re: **Site Servicing Plan Review**
Proposed Multi-Storey Buildings
Greystone Village - Phase 3 - Scholastic Drive - Ottawa
to: Regional Group - Mr. Evan Garfinkel - egarfinkel@regionalgroup.com
date: June 6, 2022
file: PG5383-MEMO.03 Revision 1

PG5383-MEMO.03 - FIGURE 1 Revision 1
SERVICES REQUIRING INSULATION
FOR FROST PROTECTION
June 6, 2022

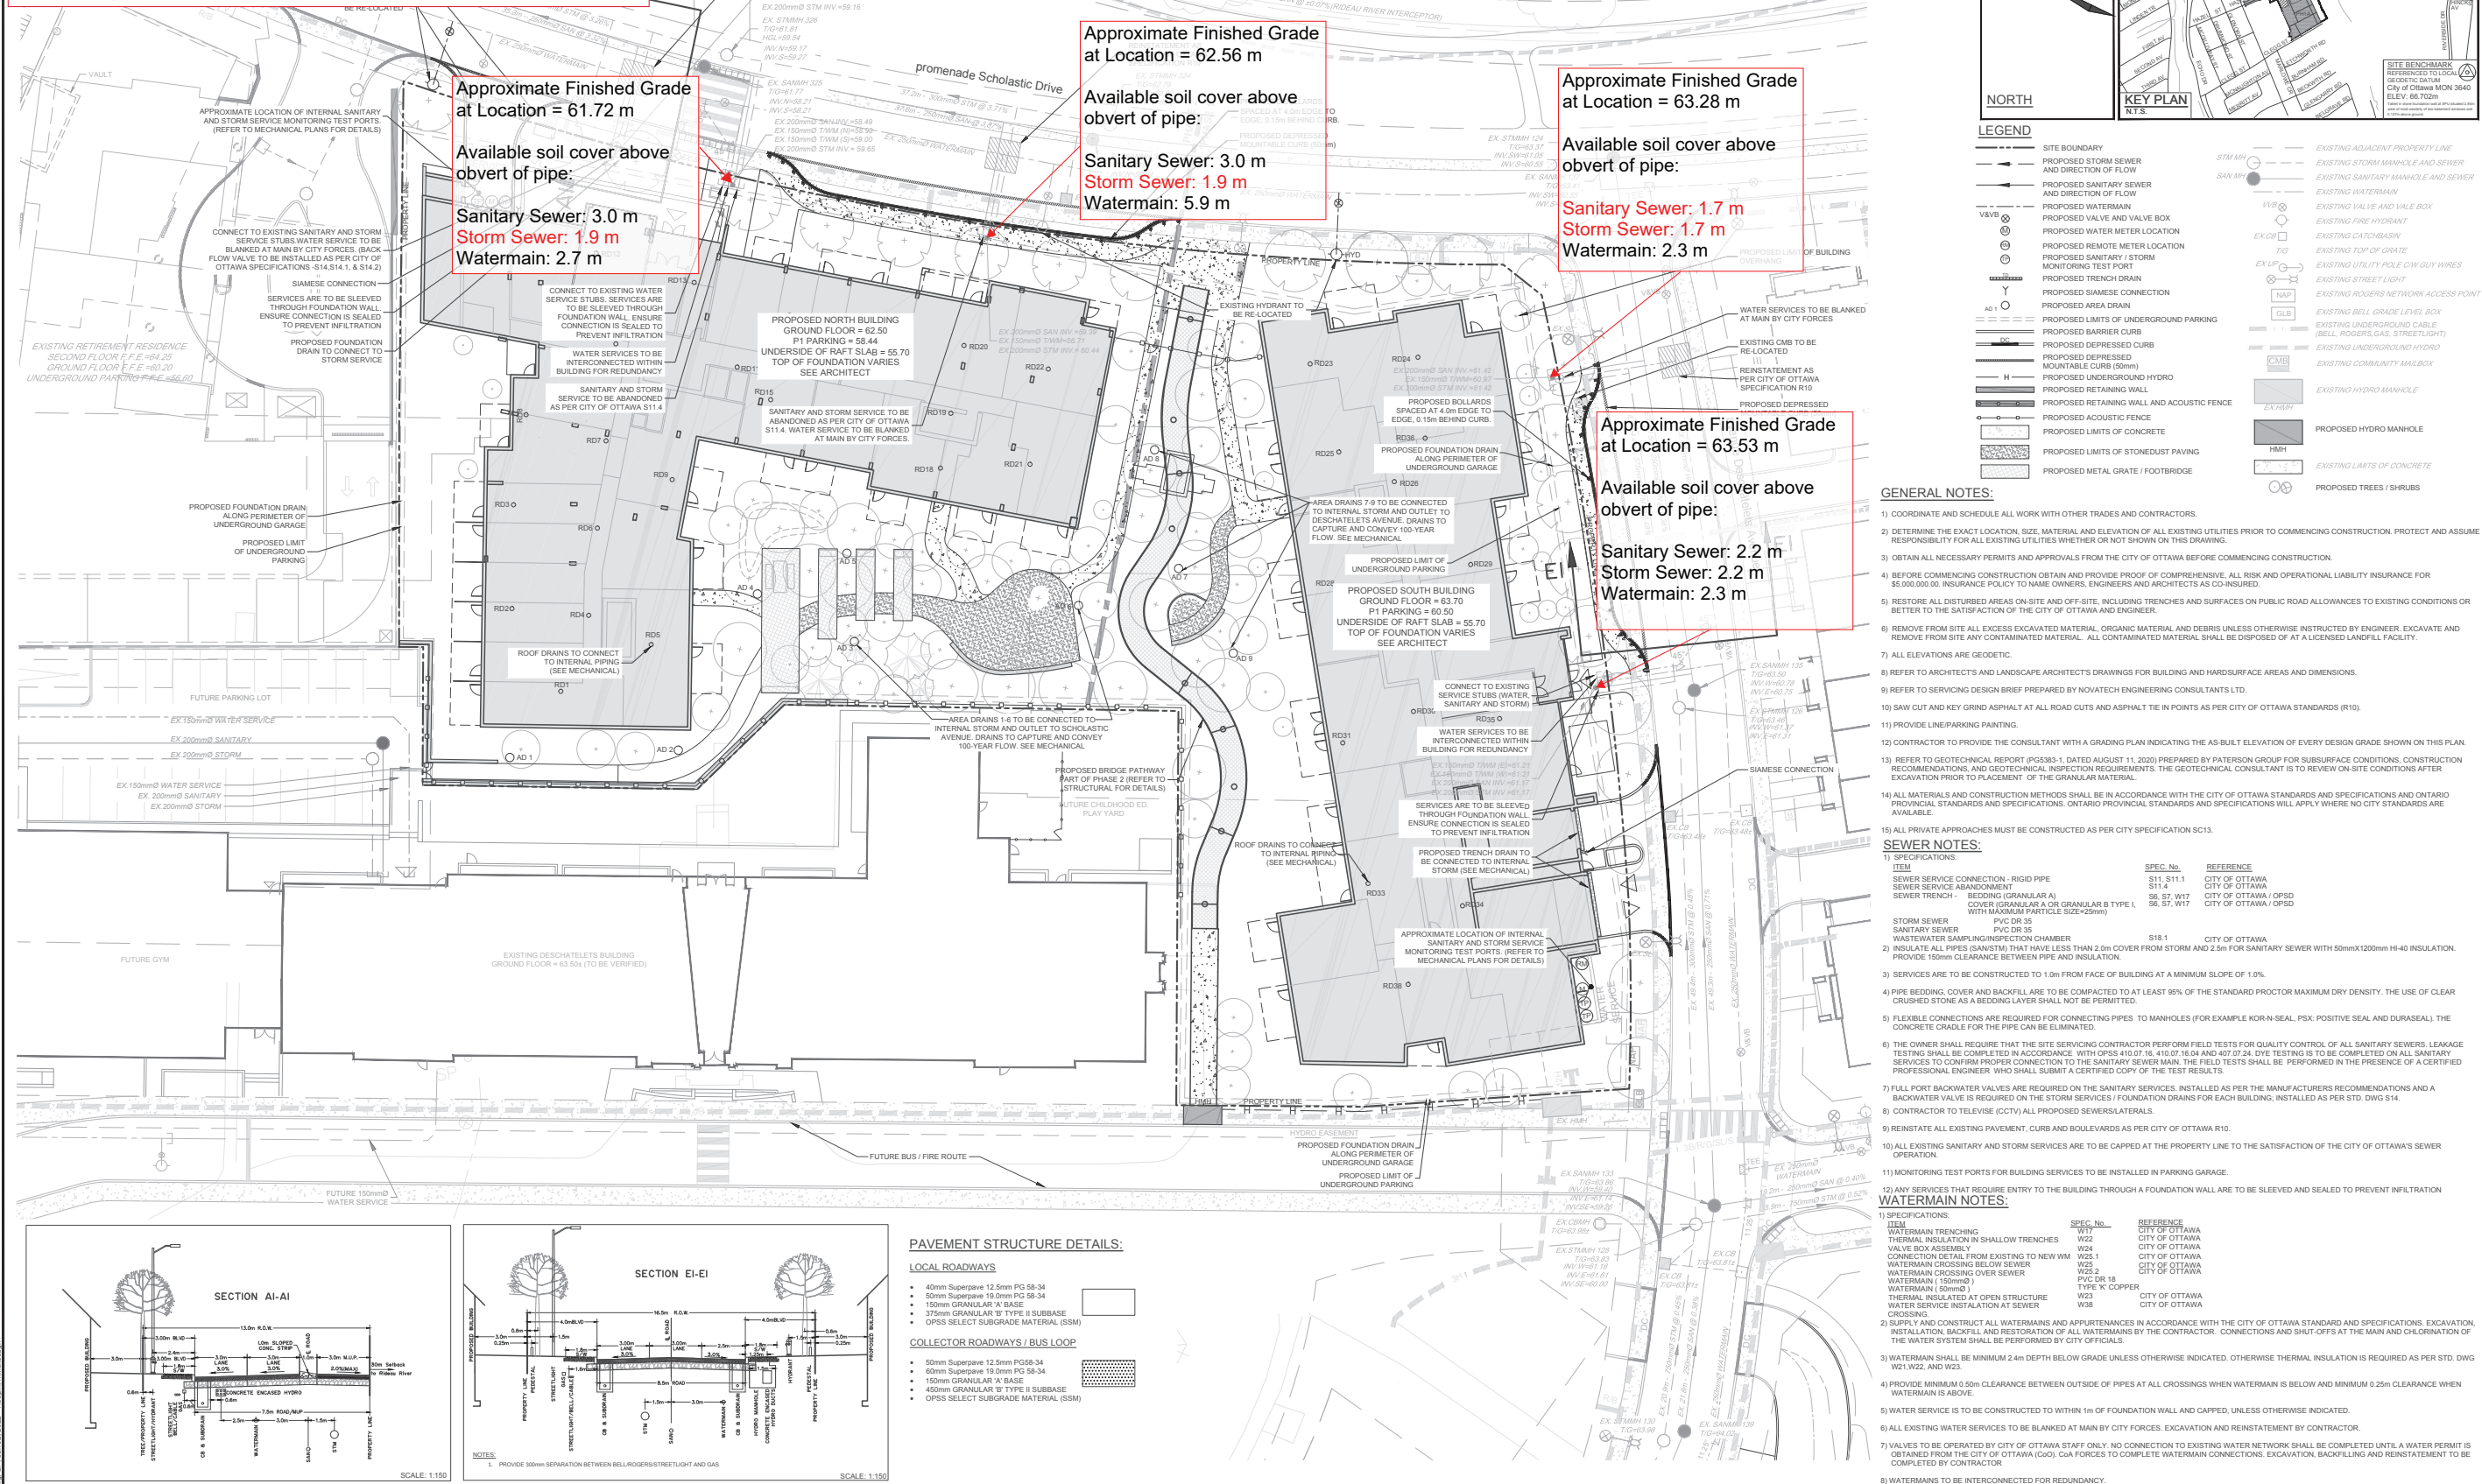
Based on our review of the site servicing plan, insufficient frost protection has been provided to sections of the storm and/or sanitary services which are noted to tie into the existing services located along Scholastic Drive and Deschatelets Avenue.

Specifically, the storm services located at the eastern portion of the site, tying into the services along Scholastic Drive, as well as the storm and sanitary services (invert elevation = 61.42 m) located within the southeast corner of the site and tying into the existing services along Deschatelets Avenue, will be founded within the frost zone (i.e. approximately 2.1 m below the finished grade). Refer to Figure 1, attached to the current memorandum, which illustrates these approximate locations. Frost protection of the site servicing is recommended where insufficient frost cover has been provided.

Any portion of the services installed at a depth of 2.1 m below finished grade or deeper is considered to have sufficient soil cover for frost protection. However, based on our review, the aforementioned sections of site servicing and their subgrades are anticipated to be founded within the frost zone. Where insufficient soil cover is present above the obvert of the pipe, the following frost protection criteria should be followed:

Table 1 - Rigid Insulation Recommendations for Sewer Pipes with Reduced Soil Cover			
Thermal Condition	Soil Cover Provided (mm)	Insulation Dimensions	
		Thickness (mm)	Extension (mm)
Unheated	1200 to 1500	50	Extend 900 mm horizontally beyond edge face of the sewer
	1500 to 1800	25	Extend 600 mm horizontally beyond edge face of the sewer
	1800 to <2100	25	Extend 300 mm horizontally beyond edge face of the sewer
Notes: All designs are based on a freezing index of 1000°C-days

Table 2 - Rigid Insulation Recommendations for Water Service Pipes with Reduced Soil Cover			
Water Pipe	Soil Cover Provided (mm)	Insulation Dimensions	
		Thickness (mm)	Extension (mm)
Watermain	2000 to <2100	50	Boxed or Extend 500 mm horizontally beyond edge face of the water pipe
		Pipe Insulation Details	
Water Service Laterals	1800 to <2100	150 mm thick Foamular XPS Pipe Insulation	
Notes: All designs are based on a freezing index of 1000°C-days

All rigid insulation should consist of either Dow Chemical High-Load 40 (HI-40), Styro Rail SR.P400, or equivalent approved by Paterson. The placement of all insulation within the service trenches must be reviewed and approved by Paterson personnel at the time of construction.
